NUMBER: 23-003-20 REV. A

This bulletin supersedes Technical Service Bulletin (TSB) 23-003-20, dated January 18, 2020, which should be removed from your files. All revisions are highlighted with **asterisks**** and include new RRT number and updated build date.**

Driver Side Seat Trim Panel Replacement

2019 - 2020 (M6) Jeep Compass

Fig. 5
Trim Piece Difference

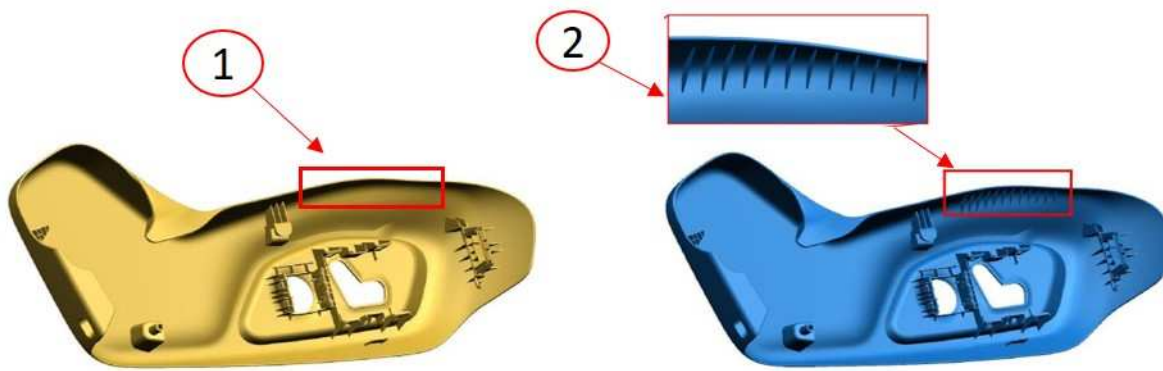
6. Discard the old trim piece, then verify that the new trim piece has the reinforced design (Fig. 5) .

- 1 - Old Design
- 2 - New Design
